SUBJECT: 1977 Annual Report on the Space Shuttle

NASA's Response to Comments  
made in the  
Aerospace Safety Advisory Panel Annual Report  
on the Space Shuttle Program  
dated March, 1977

# ACCUMULATED ENGINE RUN DURATION

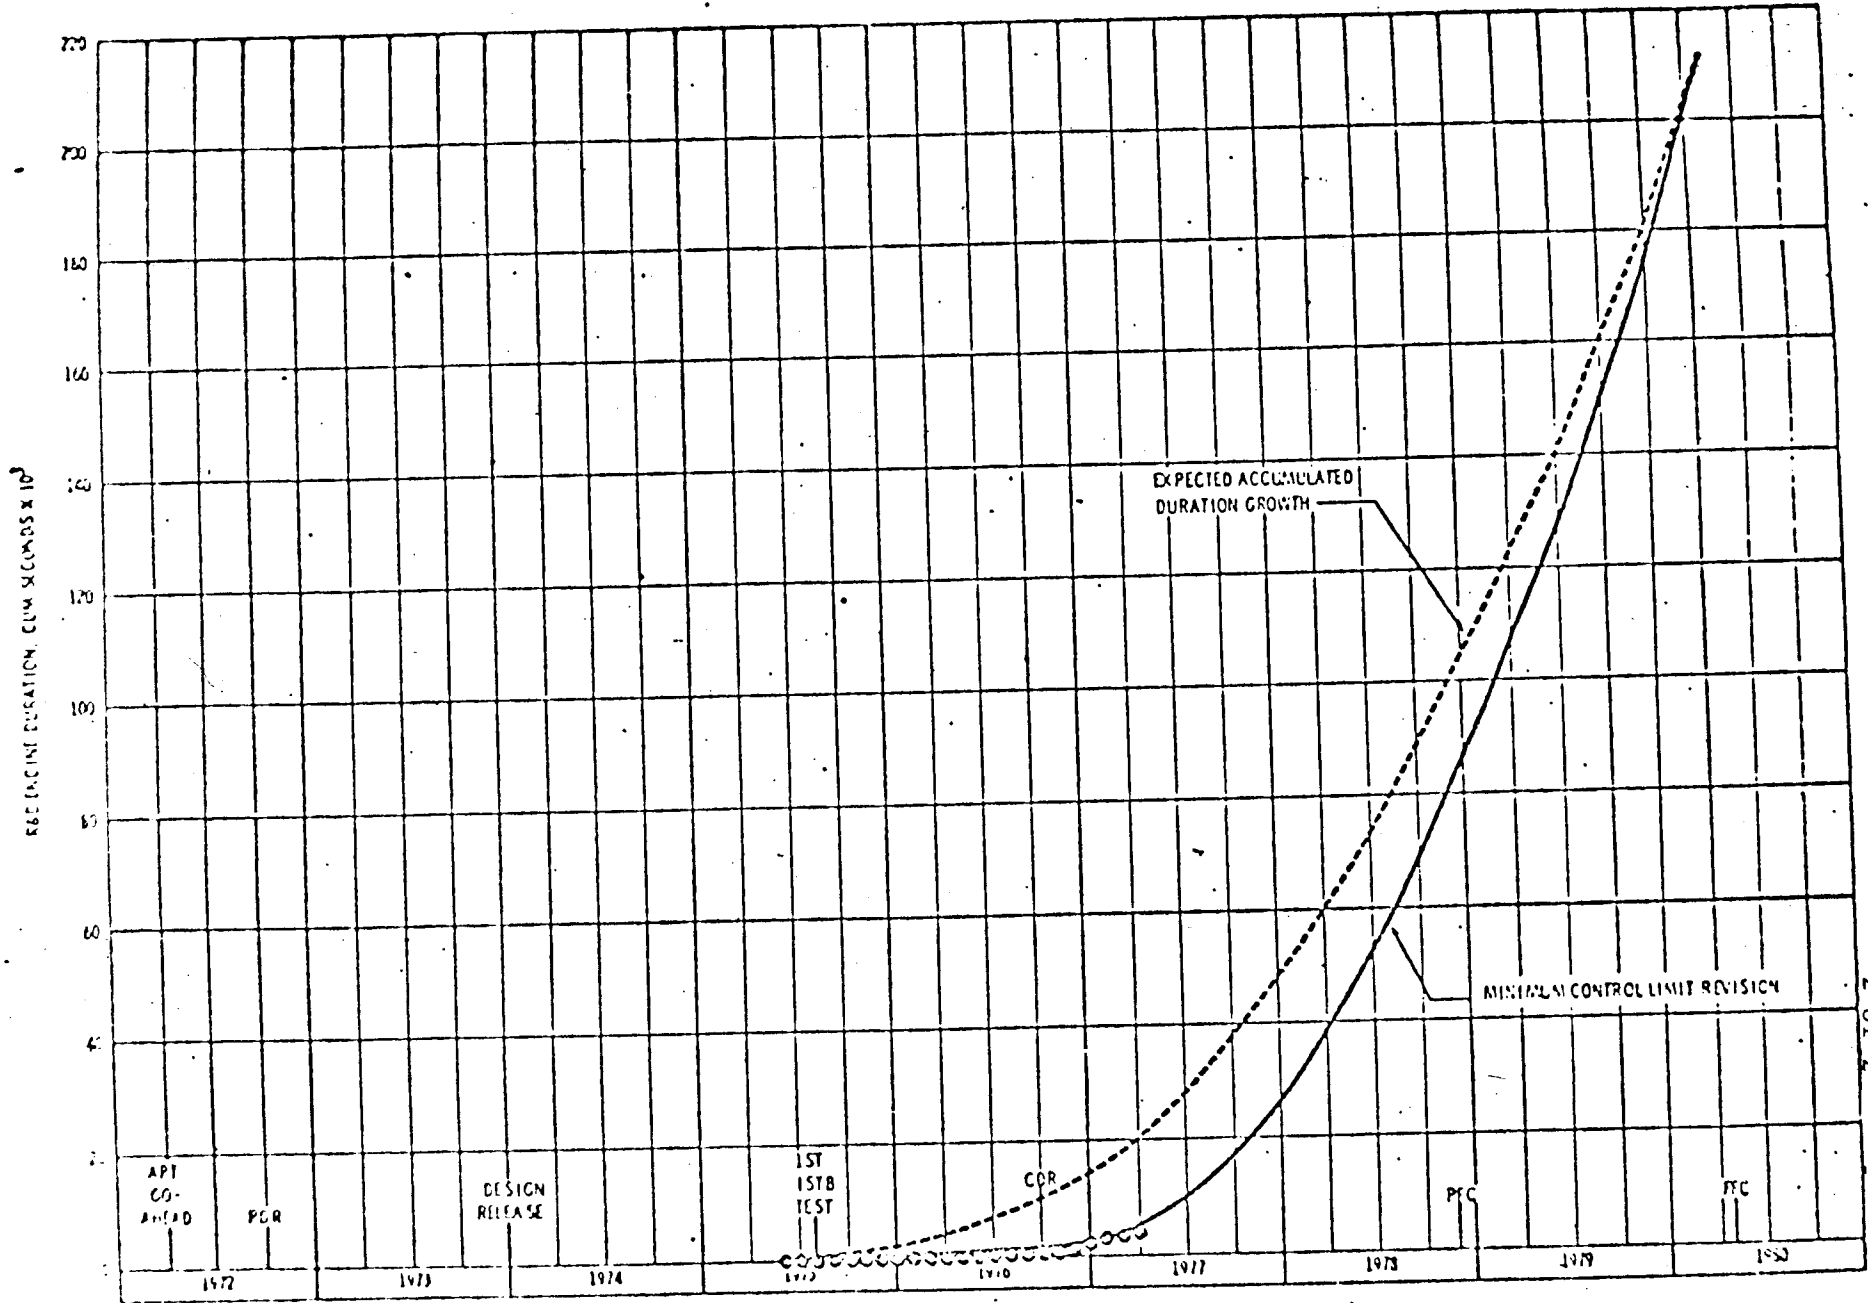
Recommendation: "2. If these requirements are not met in a timely fashion the program will, of course, face important judgments as to how to guarantee the necessary test time to certify the engines for manned orbital flight. As noted in last year's Annual Report, the planned test program called for fifty-six hours of engine testing in Final Flight Configuration which compares favorably with the test time accumulated on the Saturn F-1 and F-2 engines. Contingency or recovery planning must provide management either the realistic schedule to meet such an objective or the significance of any deviations from that goal in term of the effect on the basis for confidence in the flightreadiness of the engine."

Conclusion: SSME test planning has been adjusted to accomplish the necessary goals prior to First Manned Orbital Flight (FMOF) as well as Final Flight Certification (FFC). An "Accumulated Run Duration" plan (attached) has been established and Project progress is reviewed with MSFC Center Management and Space Shuttle Program Management. In particular, the test progress is reported monthly in the Monthly Director's Review to Dr. Malkin and the progress of the SSME Project against this plan should be used to assess the progress.
